SEWAGE DISPOSAL SYSTEM

HOWARD COUNTY HEALTH DEPARTMENT

SUBDIVISION Gifford Dye Property LOT 20 ROAD 14295 Old Frederick Road

RE: Gifford Dye Property - Lot 20
14295 Old Frederick Road
Building Permit Application: 50172

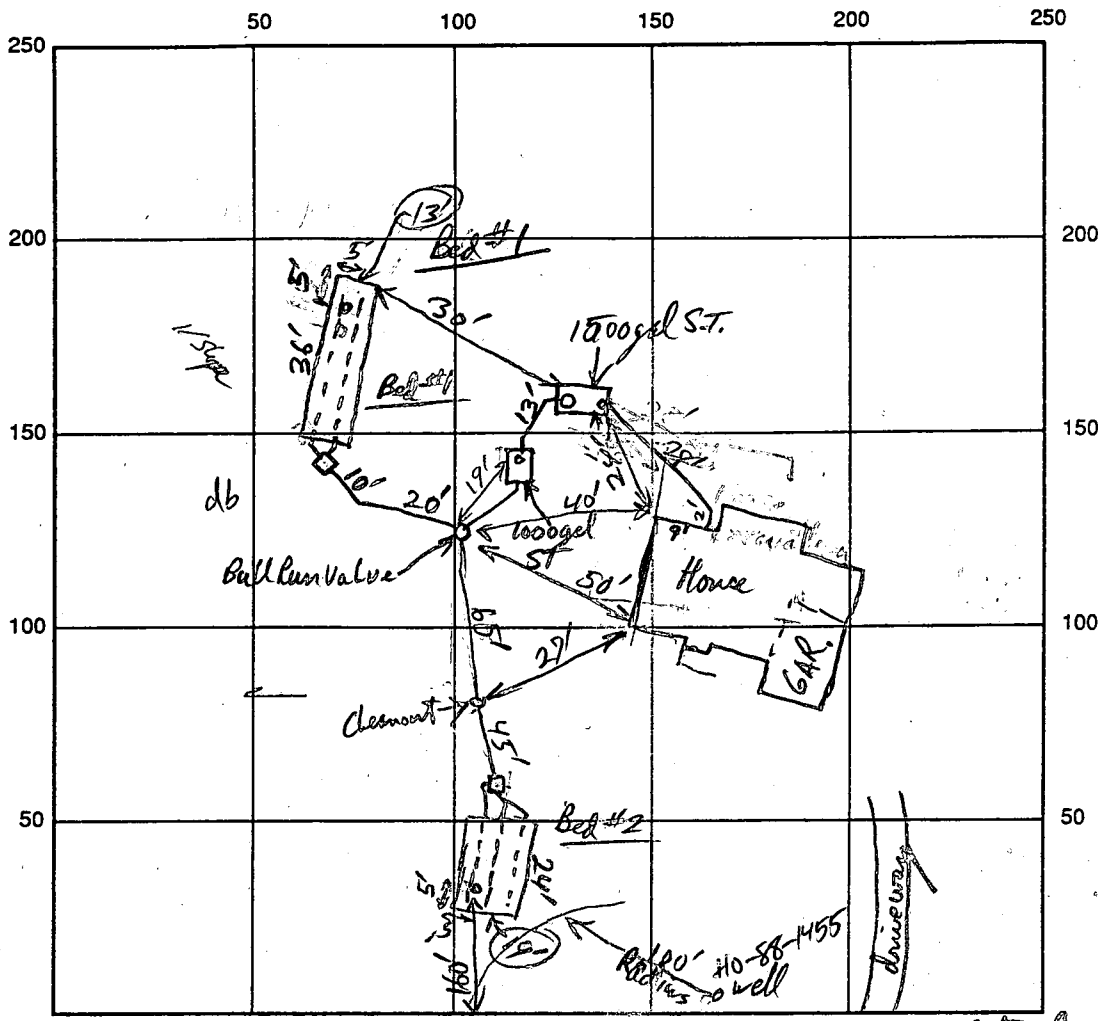
REMARKS: Beds OK to fill with stone 10/14/93 Beds OK to cover, 1st septic Tank Set 10/14/93
2nd Tank OK, piping OK, OK to cover. Call for house connection when ready 10/18/93
HSE connection OK, OK to cover system 12/27/93 PJ

Note on Bull Run Valve - setting #1 in use Now leads to Bed #2 (and vice versa)

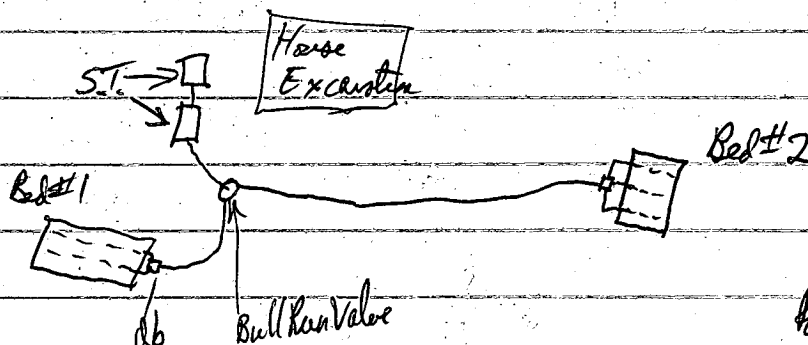
put one o.p. in each bed about (4x6) 3' from each edge at downslope end of bed.
Bed #2
change to 24' long by 19' wide
cut getting too deep at upslope end
10/14/93
Ronald J. P.../K...
10/13/93

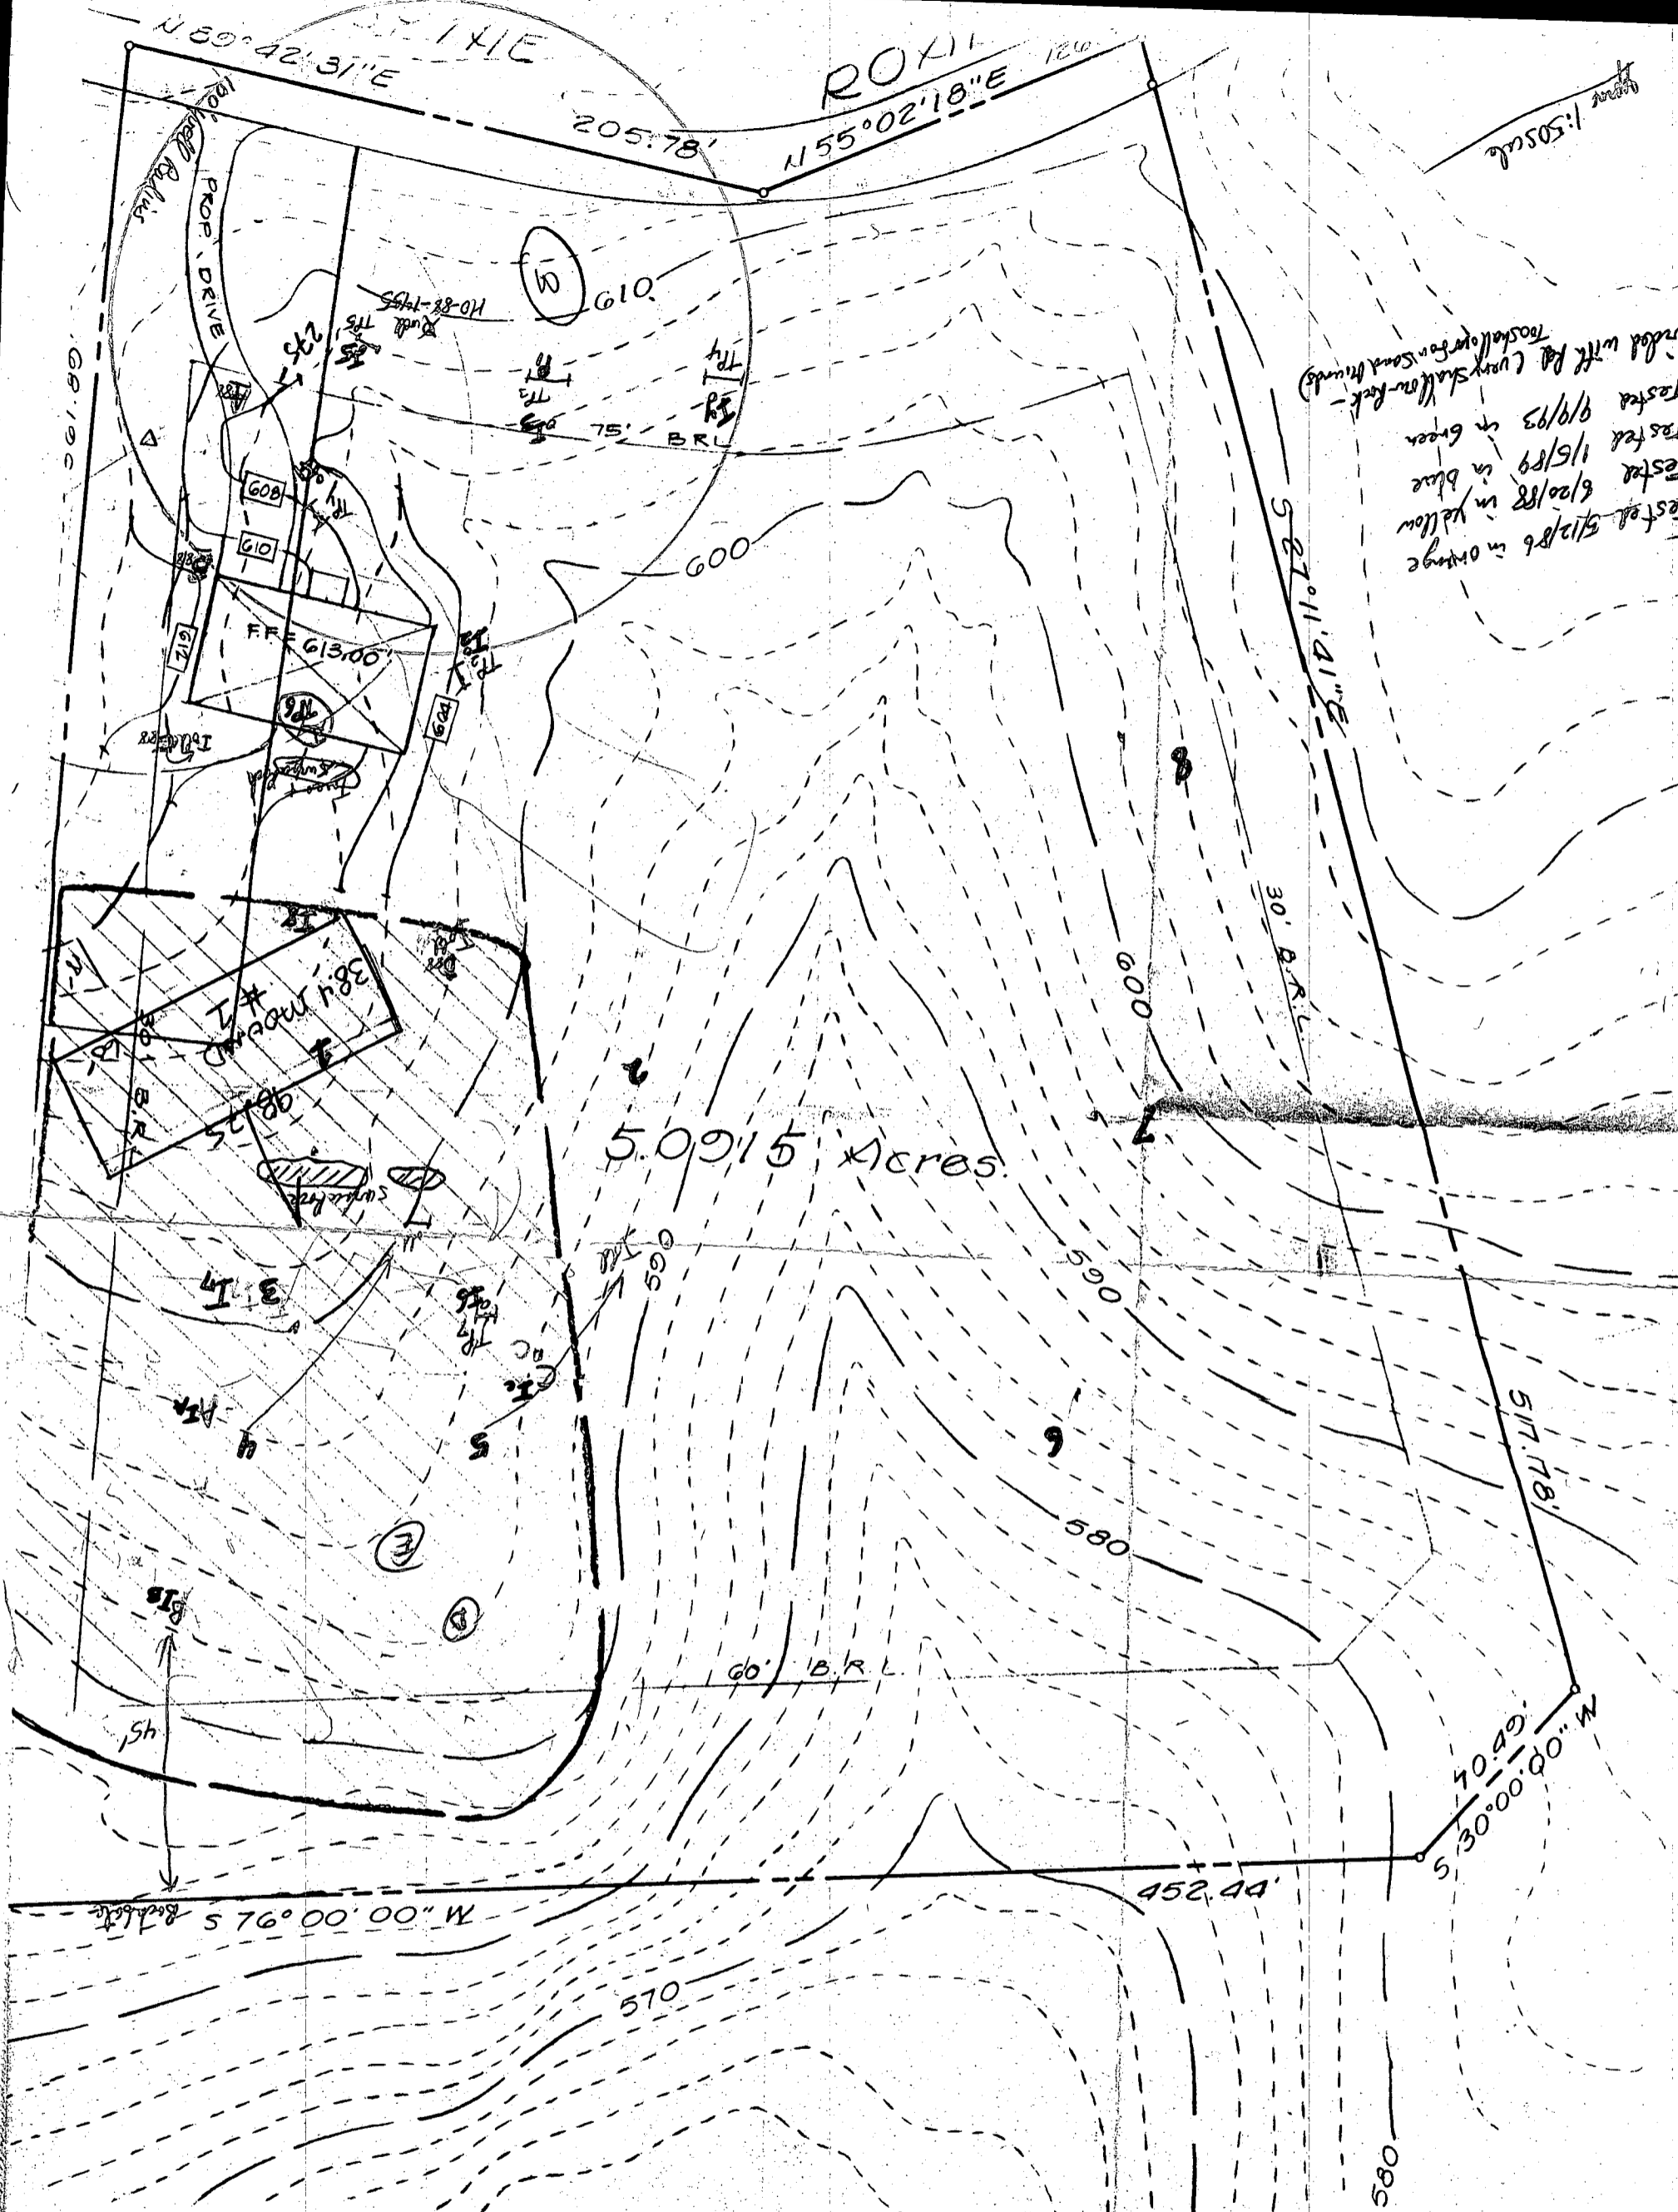
Back Area of Blue (between large surface rock and rear ledge) I7 @ 16-21" 20 mpi (2 1/2" drop)

TP7 I6 @ 15-20" prob 60 mpi (1 1/2" drop)

9-9-93 by R.J. Pinkley (Rock @ 3 1/2 - 5') A I_A @ 20-26" est 160 mpi (2" drop)

(11" deep Rock 1/5 4' 1/2") B I_B @ 15-20" est 240 mpi (1 3/4")
